## ARCHITECT'S ADDENDUM

Addendum Number: 004

**RE:** KANE COUNTY - Multi-Use facility

Subject: Addendum No. 004 to the Construction Documents for the Kane County Multi-Use Facility.

NORTH  
1 FIRST FLOOR PLAN  
1/16" = 1'-0"

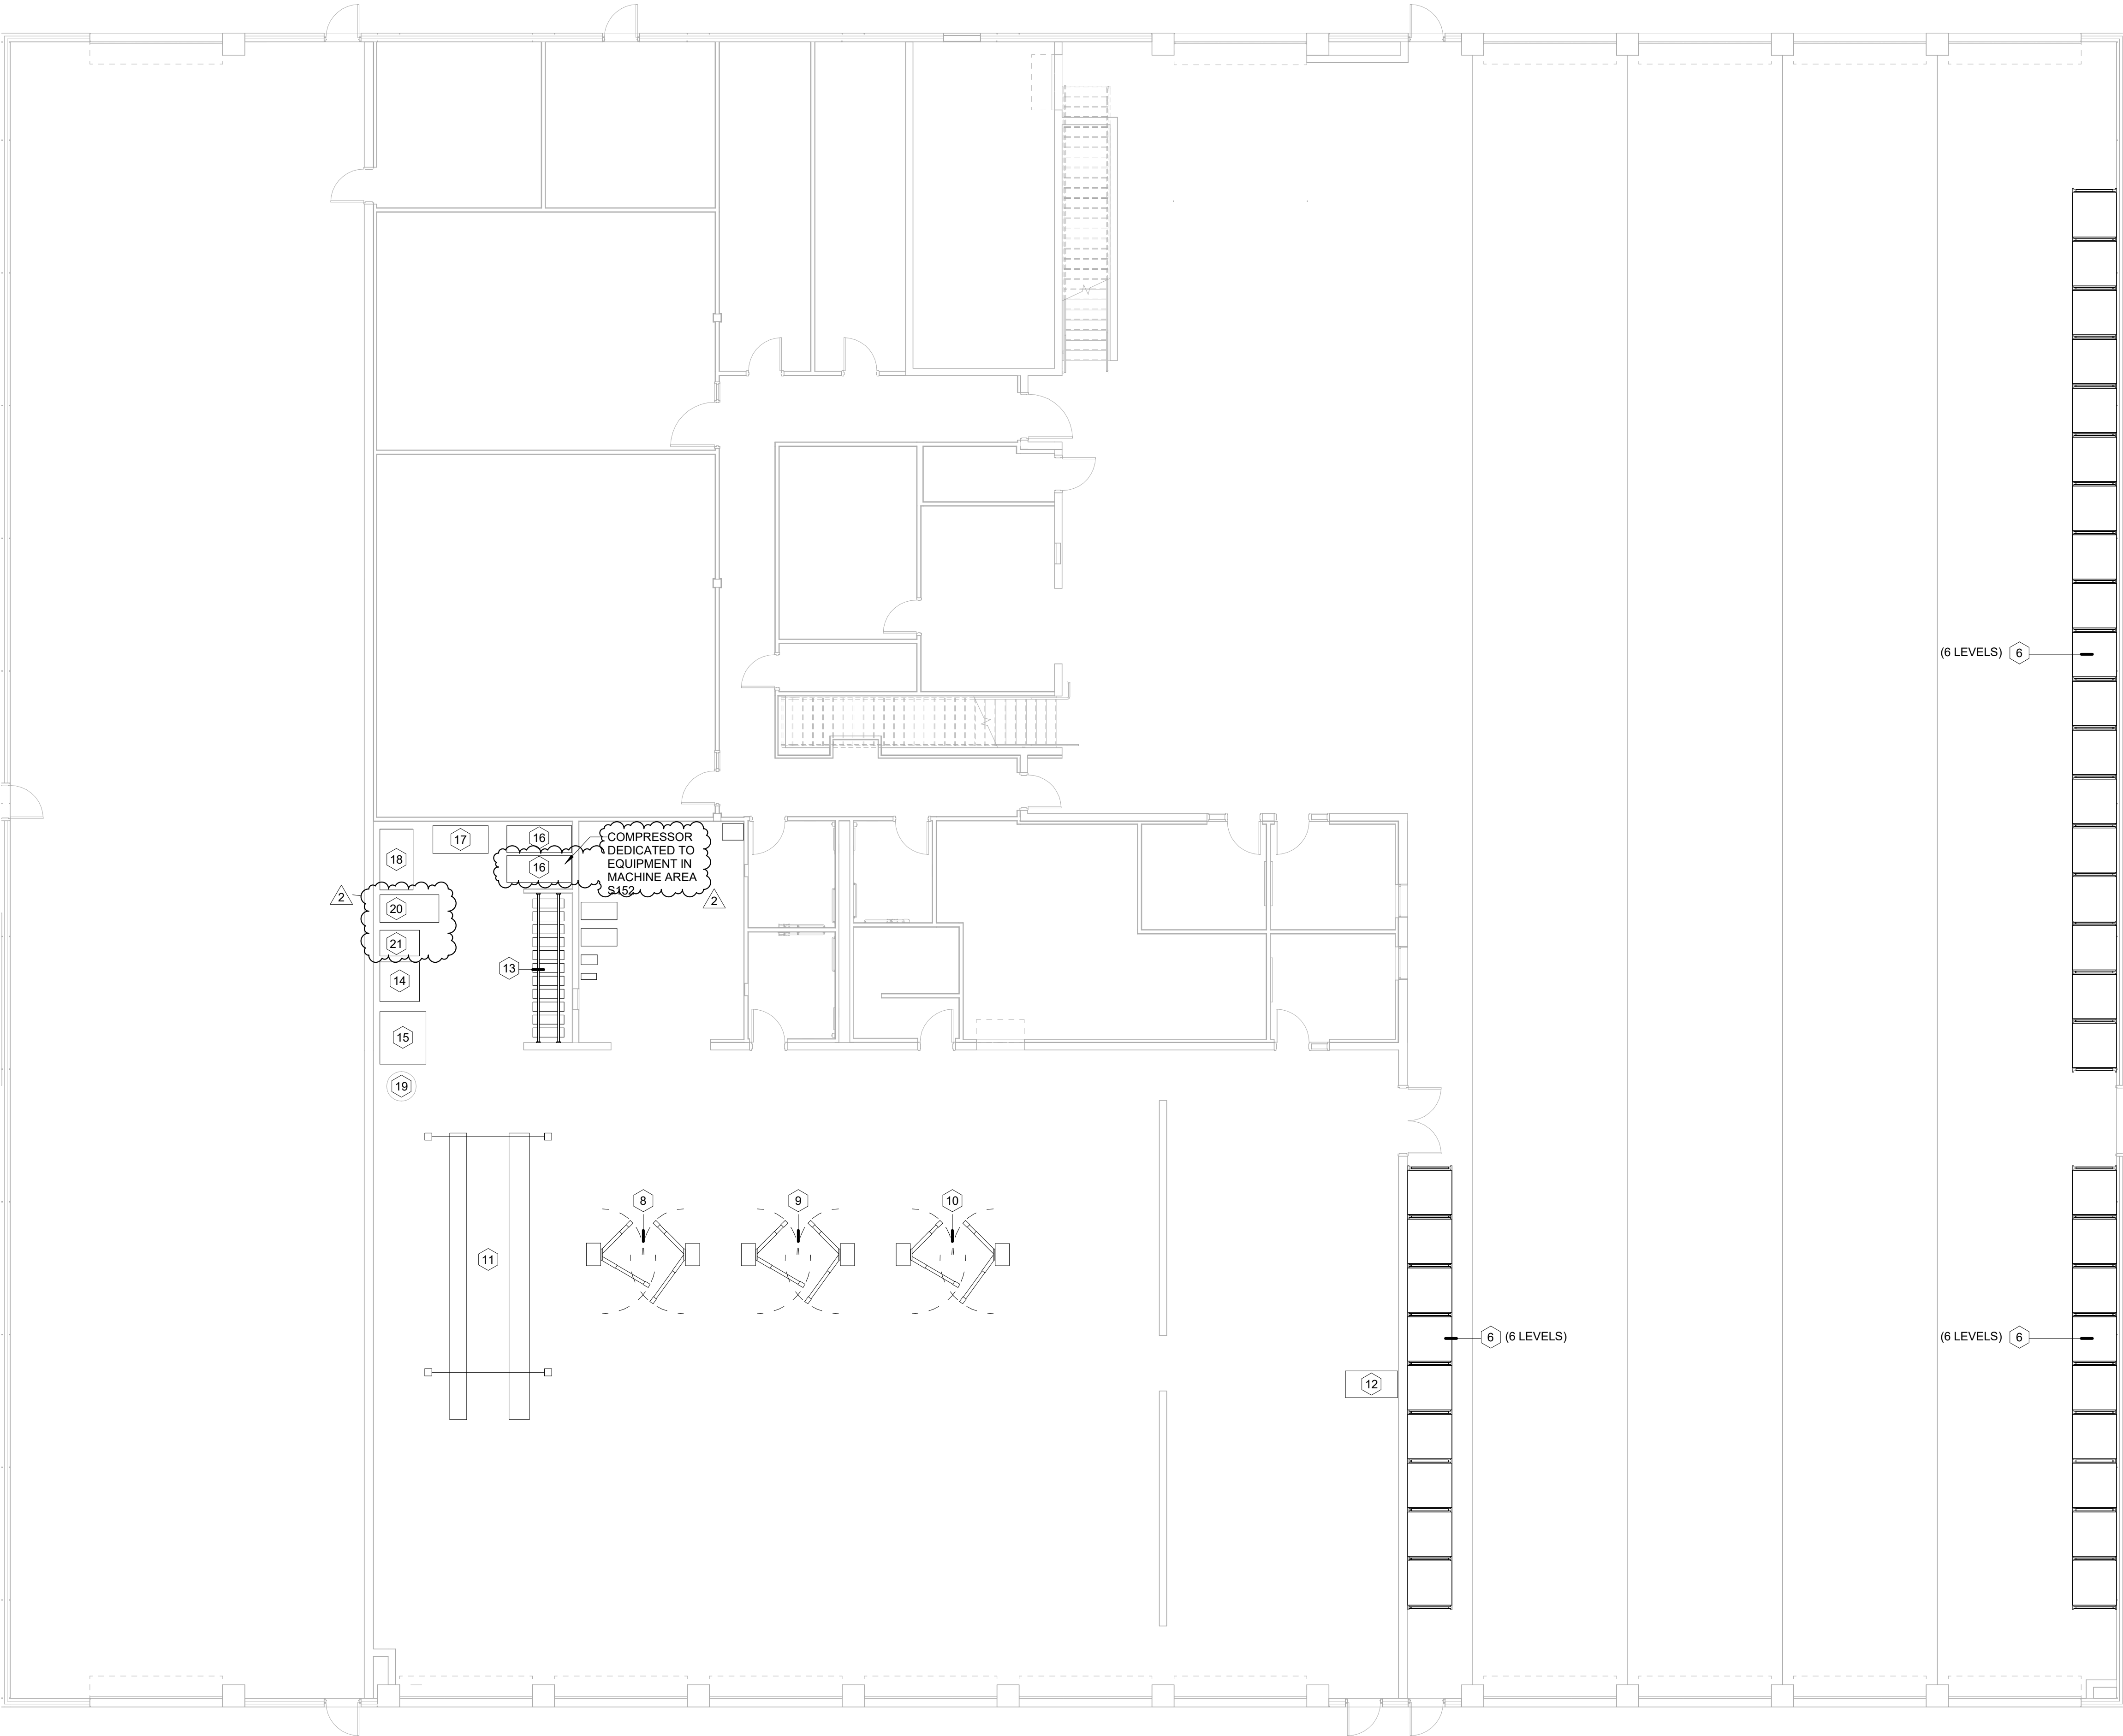
6	Rail openings at mezzanine	A2.2, A2.2A, A6.4, A8.2 and A8.3 - revised and attached herewith		Arch	12.30.19	(2) 4'-0" Removable Rail Section
7	Equipment	A10.1 and A10.1B - revised and attached herewith	112100 - revised and attached herewith	Arch	12.30.19 and 01.07.20	All equipment to be provided by contractor. Equipment location/mounting as per owner's direction.  Refer to revised Equipment Schedule and Division 112100, sub section 2.1 Equipment
8	Exterior Thin Brick Selection			Arch	12.30.19	<u>Thin Brick:</u> TBRK-01 - Summitville - 97 Valley Forge; Size: Norman; Texture: Velour TBRK-02 - Summitville – 27 Georgetown; Size: Norman; Texture: Velour  <u>Face Brick:</u> BRK-02 - to match thin brick TBRK-02
9	Trash Enclosure	C2.1 and L 200		Civil/ Landscape	12.30.19	Ignore chainlink fence around trash enclosure and GENSet enclosure. Follow Details on A1.1A
10	Storefront Type C3 and Type C4	9/A9.2			12.30.19	Correction to glazing for Type C3 and Type C4 shall be IG-1.

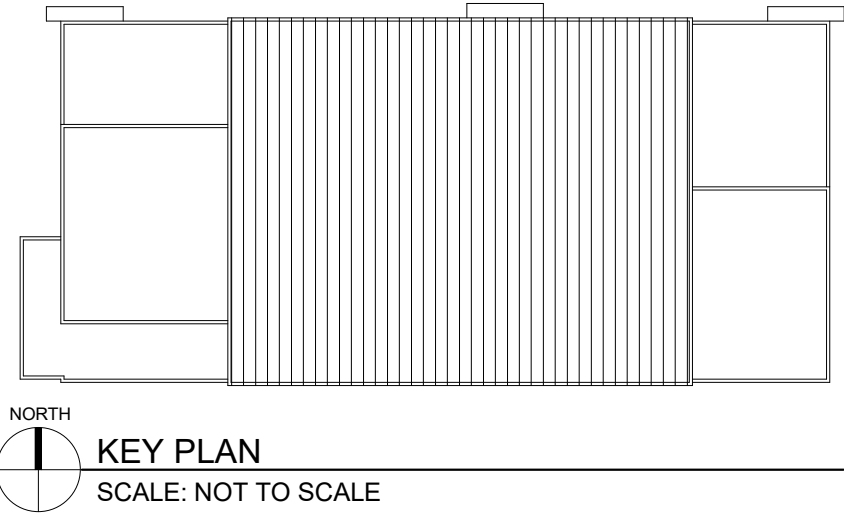
14	Ceiling Symbol Legend	A3.1B - revised and attached herewith	112100 - revised and attached herewith	Arch	01.07.21	Added "Ceiling Symbol Legend" to clarify symbols for ceiling hose drops for tranmission fluid, compressed air, power, grease and water distribution systems.
